SECY-82-431

REVIEW OF DIRECTOR'S DECISION DD-82-11  
(MATTER OF ROCHESTER GAS AND ELECTRIC  
CORP.)

GINNA Nuclear Power Plant

DIRECTOR'S DECISION UNDER 10 CFR 2.206

FIGURE 1

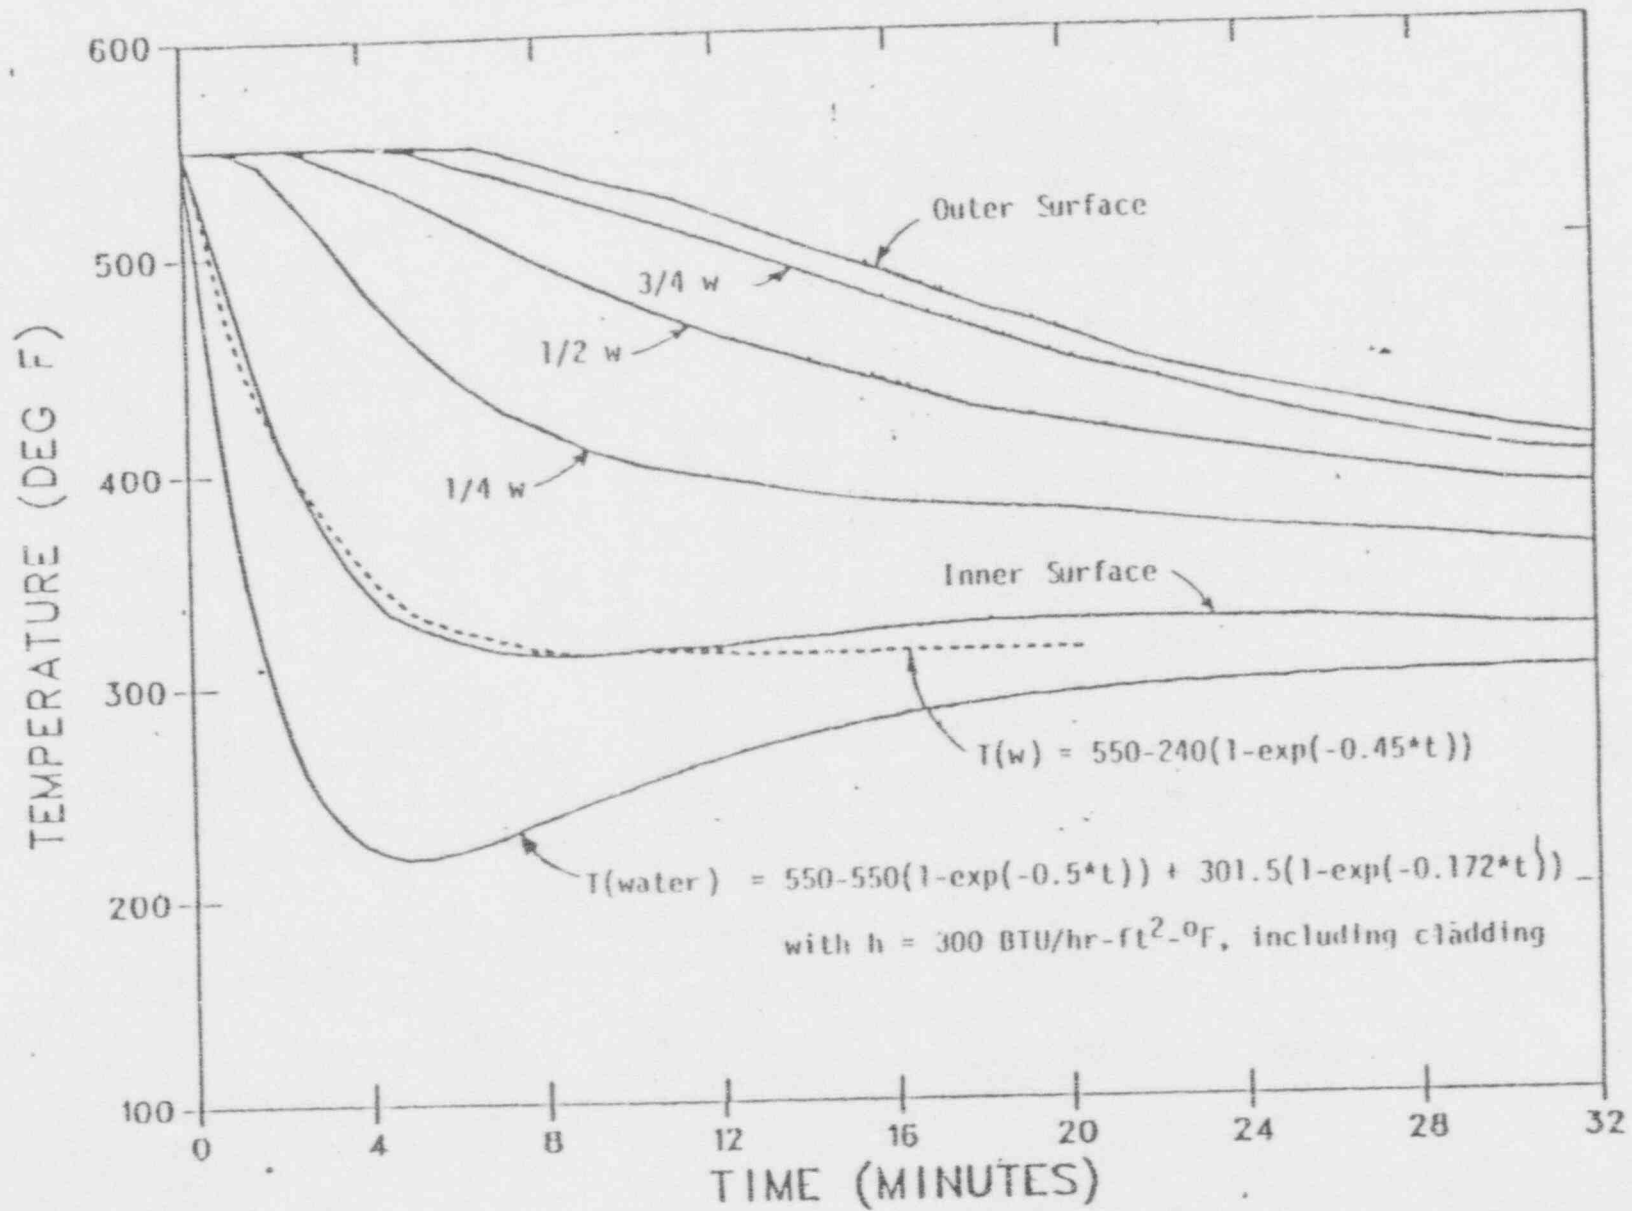
A.2 Staff analysis of B loop circulation. The thermal shock analysis provided by the Task Force in NUREG 0909 and reiterated with some elaboration in NUREG 0916 at 3.5.2, is not, in our opinion, adequate to support staff's contention that flow reversal in the B loop prevented cold water as measured by the temperature sensor from entering the reactor vessel.

Staff has apparently made no attempt to model the hydro-dynamics of the primary loop flow during the period of temperature drop. Such a model must not only account for the mass balance, but also for all relevant dynamics such as buoyant and viscous forces and turbulent mixing. Lacking such a model which integrates the various forces, staff's attempts at explanation of the system dynamics remain unconvincing. For instance, staff suggests that the steam generator is a heat source which causes loss of natural circulation flow in the B-loop, without mentioning any other factors which would effect flow.

Other potentially important dynamics are ignored by staff. For instance, staff fails to discuss the flow consequences of the RCS pressure falling below the S/G B pressure, resulting in reverse flow through the tube rupture during the PORV openings. Nor does staff attempt to analyze the dynamics by which water lost from the B loop through the burst tube and PORV is replaced in the system. The question of stratified flow with some cold safety injection water being drawn into the reactor is certainly not answered by staff's vague reference to use of EPRI data. (NUREG 0916 at 3-15)

Staff asserts that even if cold water had entered the reactor, fracture mechanics analysis indicates that there would be no crack initiation. We are given almost no information about this analysis; however, we are told that the temperature used was that measured by the sensor in the cold leg of the B loop. (Ibid. at 3-15) This is portrayed as a worst case analysis, despite staff's recognition on the previous page that the temperature entering the reactor could be 10° less than the measured temperature.

The staff is currently performing an analysis of the R. E. Ginna steam generator tube rupture event of January 25, 1982. The RETRAN 02<sup>(1)</sup> computer program is being used to perform this analysis. Results of this analysis are expected to be completed by the end of the year. We believe this analysis will support the conclusions of NUREG-0916 concerning pressurized thermal shock.

1. Temperature History Effect

Due to the thickness and thermal conductivity of the vessel wall, temperature changes of the coolant at the vessel surface propagate more slowly in the vessel wall. The thermal time constant of the wall is on the order of 30 minutes<sup>(2)</sup>. An example of the temperature distribution in a vessel wall as a function of time, for the specified thermal transient, is shown in the attached figure. Temperature fluctuations in the water, the period of which is a few minutes or less (for example, less than the vessel wall thermal time constant), have little effect on the temperature distribution in the wall and it is possible to use the average surface temperature curve in fracture

mechanics analyses. The Ginna SGTR event falls into this category. The effect of the vessel inner wall heat transfer coefficient is the greatest in the most rapidly changing parts of a transient. Note that for the case illustrated, the metal surface temperature as a function of time can be closely approximated by  $T(\text{wall}) = 550 - 240 [1 - \exp(-0.45 \cdot t)]$ , if a vessel inner wall heat transfer coefficient of infinity is used. Our studies to date indicate that the most critical factor with respect to pressurized thermal shock considerations is the final temperature of the water. Although our best judgment at this time is that B loop flow was in the direction of the B steam generator during the time the PORV was stuck open, we have conservatively assumed that the B loop flow was towards the vessel for the entire duration of the transient. In this case, the appropriate thermal characteristic (vessel downcomer coolant temperature versus time) for the Ginna SGTR event is that specified as Case 1, from Figure 2.4 of NUREG-0916, with uncertainties associated with instrument errors and mixing of the cold safety injection water. Case 2, from Figure 2.4 of NUREG-0916 is a conservative lower bound of the B loop coolant temperature designed to encompass the short duration coolant temperature decrease associated with the open PORV. This lower bound is equivalent to adding a total uncertainty of over 60°F to the Case 1 figure. Thus, the Case 2 temperature characteristic bounds the estimated uncertainties in the downcomer temperature (10°F to 20°F for mixing plus 15°F

to 25°F for instrument errors). The conclusion that no crack initiation occurred during the SGTR event, based on the Case 2 fracture mechanics analysis, is, therefore, confirmed.
